Title: Planning Comments Response

Date: 16.03.2025

1.1 This Technical Note is to address the planning comments for the development at Chickenhall Lane. The comments from EA, LLFA and Ecology are addressed below:

LAND EAST OF CHICKENHALL LANE,, EASTLEIGH, SO50 6AF

DRAWING No:
JUBB-XX-XX-DR-C-0500

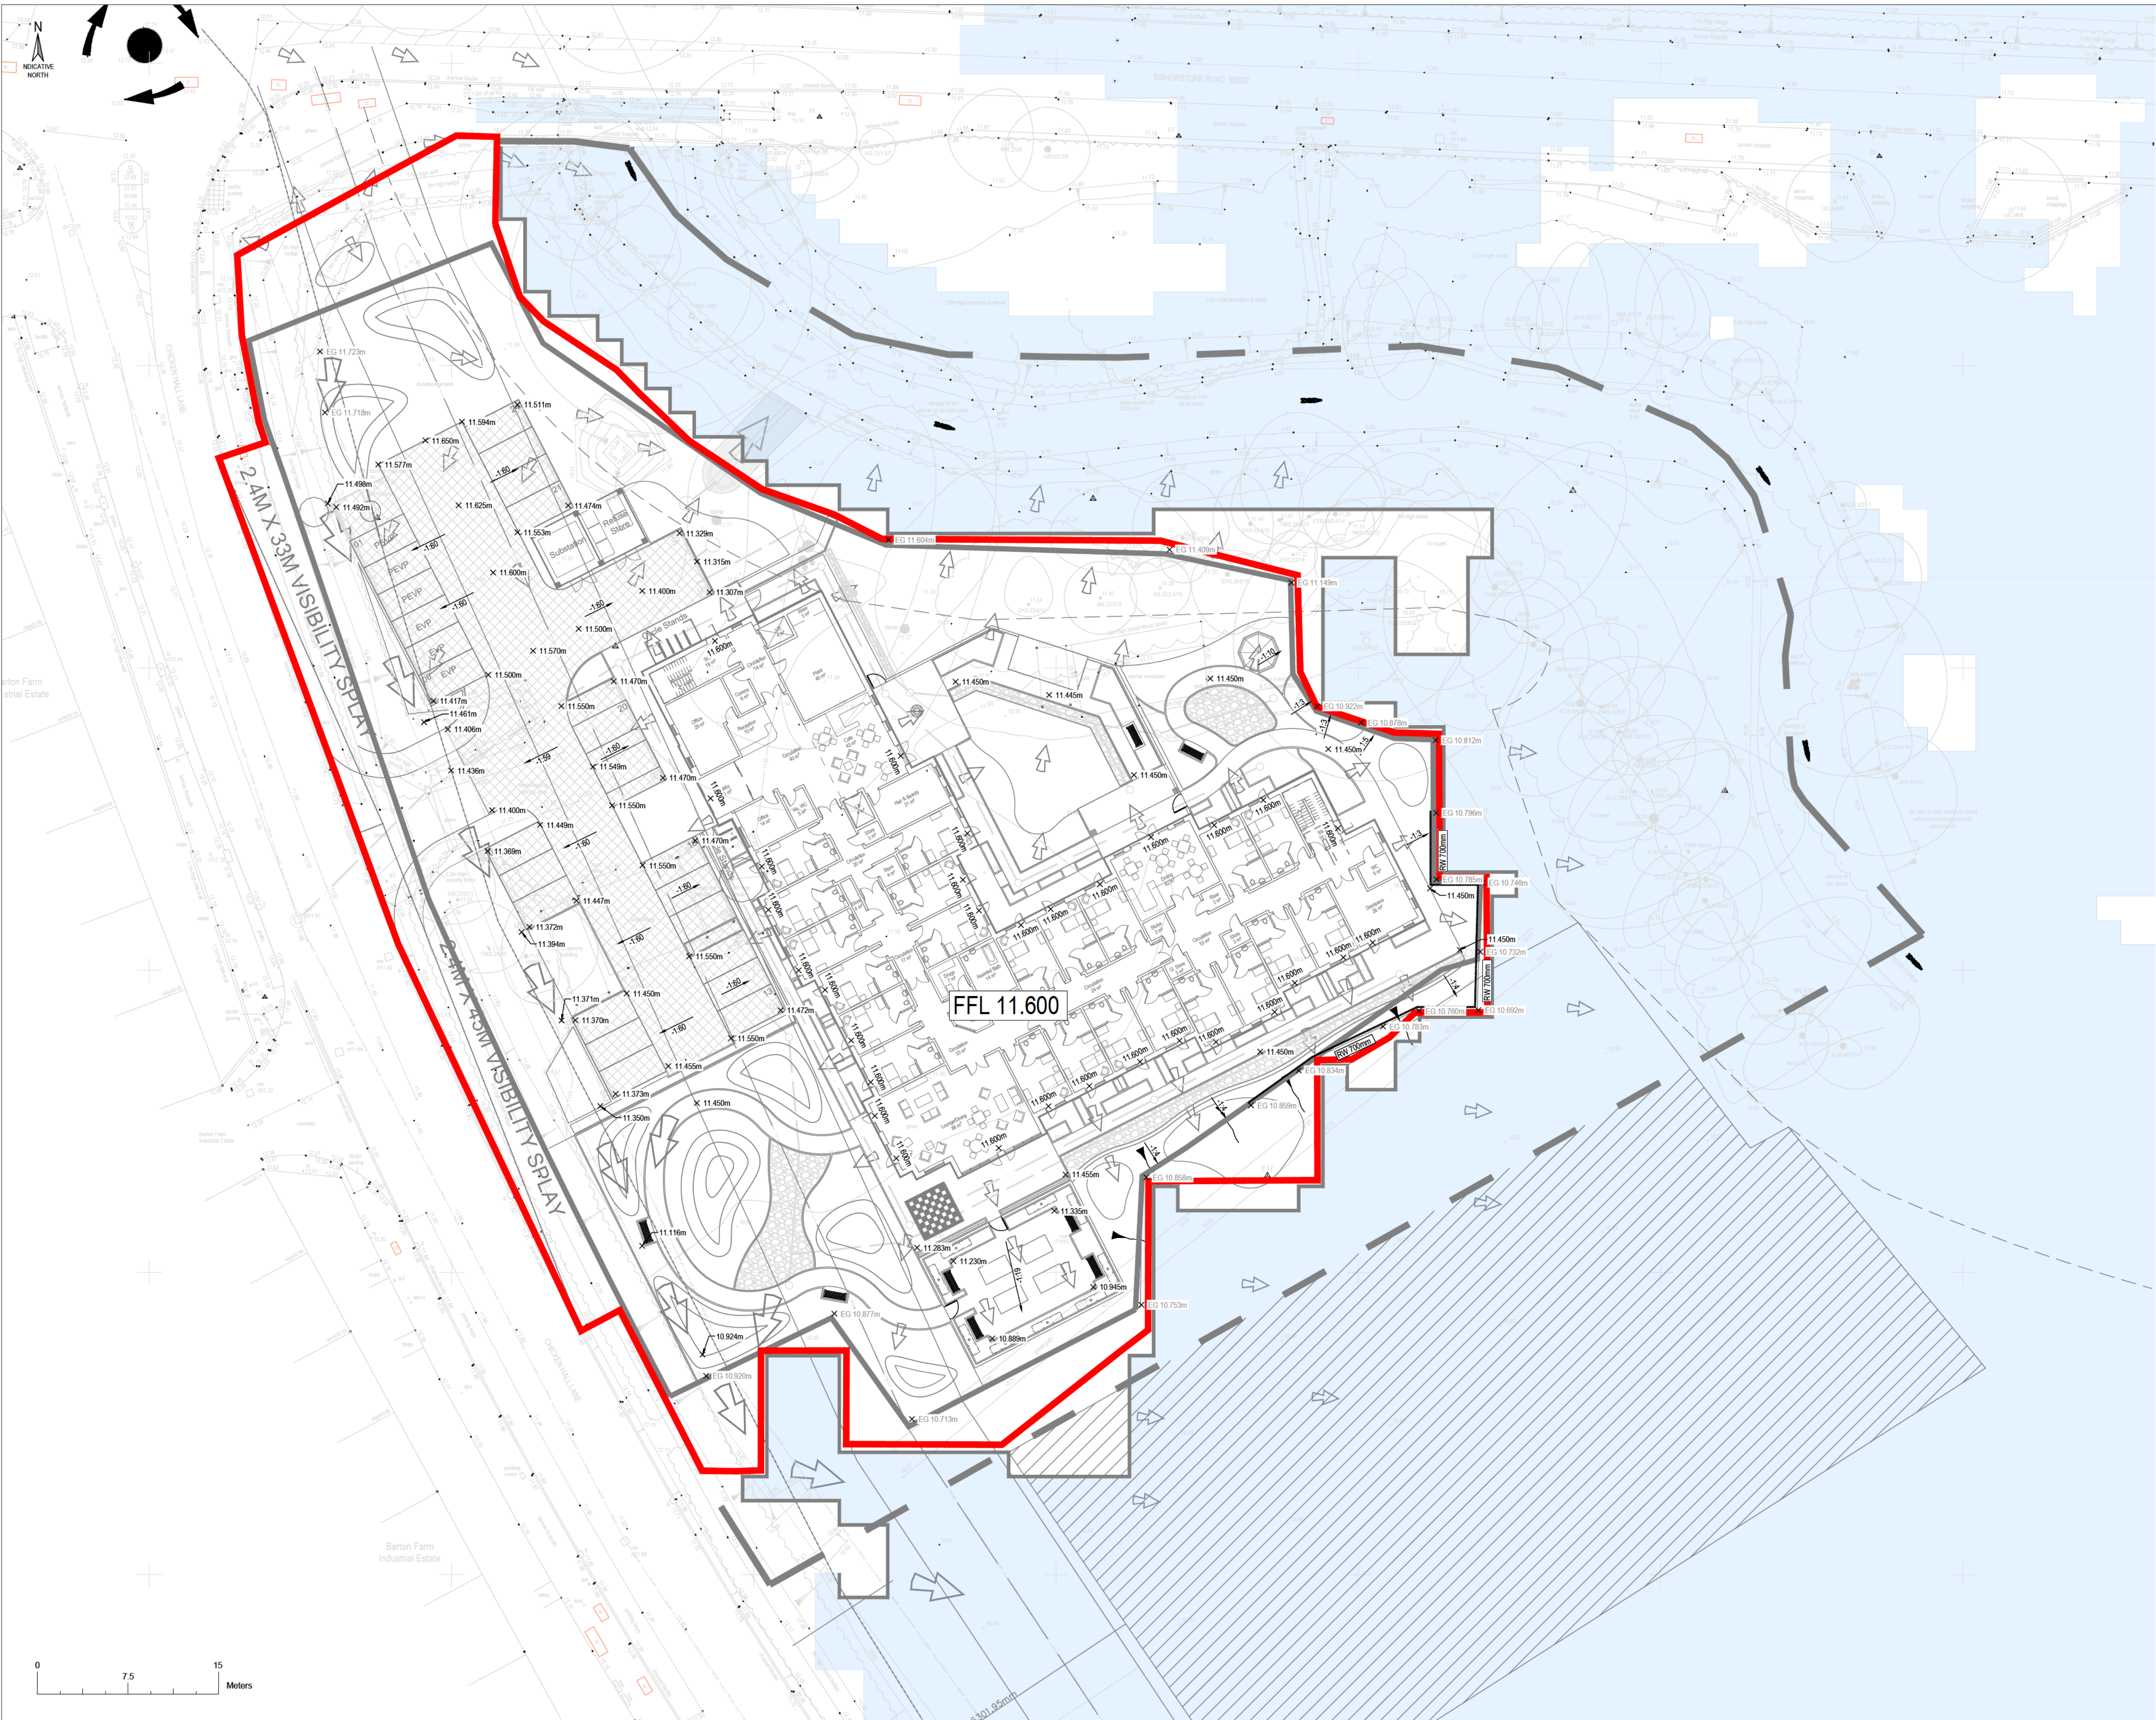
ix. *"The surface water drainage strategy for this application lists four rain gardens, French drains, permeable paving and a swale as forms of treatment for runoff, however it has not been demonstrated that all of the surface water will be treated by all of these components. The proposed swale is located outside of the red line boundary and is too short. It would not function as a form of water treatment when overtopped by high water. The surface water drainage from the car park would only have one form of treatment provided by the permeable paving."*

xii. *Information has not been provided on the flow of surface water through the system and the effects of high groundwater on the proposals. A diagram showing the path of each surface water flow with arrows would be required to demonstrate that all of the surface water passes through at least 3 forms of naturalised filtration within the treatment train before being discharged off site.*

4.1.1 Additional forms of treatment have been added to provide 3 forms of treatment to car-park:

- Hydro Filter Channel Drain, pick up drainage directly from surface of carpark,
 - Permeable Sub-base, conveys and treats water.
 - SPEL Smartceptor, provides final stage of treatment prior to outfall
- x. *Tables 3 and 4 on the simple index approach have been copied from the SuDS manual and inferences made, but the specific calculations for the roof water and car park areas in this application have not been done. It is also not clear whether these components are compatible with the high ground water levels on site. The site investigation reported ground water encountered at depths from 0.58 m to 1.22m below ground level, so ground water flooding must also be considered.*
- xi. *Permeable paving is proposed for the majority of the attenuation and is proposed to be 0.5 m deep with 30% void storage. This is only slightly shallower than the highest groundwater.*

4.1.4 All areas onsite are routed via min. 3no stages of treatment. See updated drainage plan.
